0489-0613.1

# Engineering Evaluation/Cost Analysis for the Maywood Site Storage Pile, Maywood, New Jersey

Final September 1994 Engineering Evaluation/Cost Analysis for the Maywood Site Storage Pile, Maywood, New Jersey

# RESPONSIVENESS SUMMARY TO PUBLIC COMMENT ON THE ENGINEERING EVALUATION/COST ANALYSIS FOR THE MAYWOOD SITE STORAGE PILE

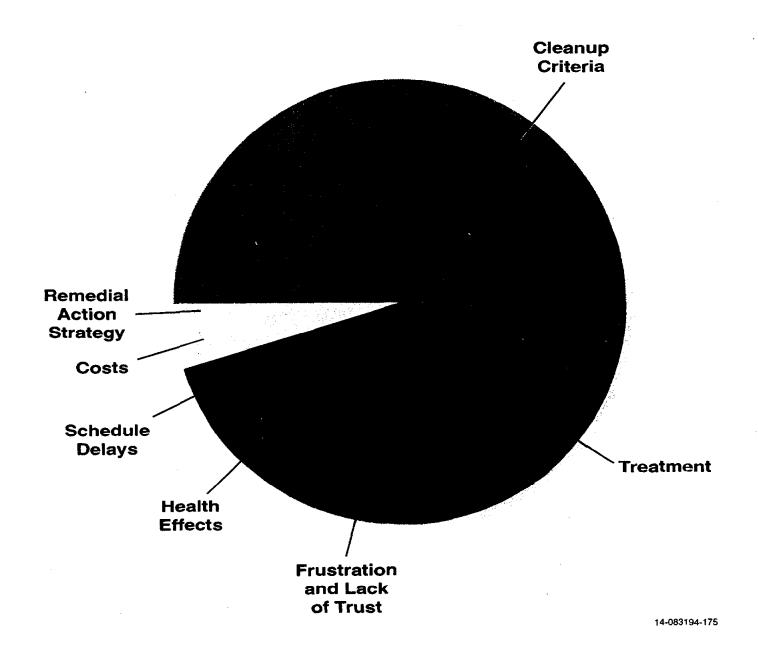
Figure 1-1 shows the relative number of comments received in each of the seven key subject areas.

Concerns about the cleanup criteria to be used for the Maywood site and the potential use of soil treatment accounted for the majority of comments. A wide range of issues were expressed on these two key subject areas. To keep the responses from becoming too lengthy, these key areas have been further subdivided.
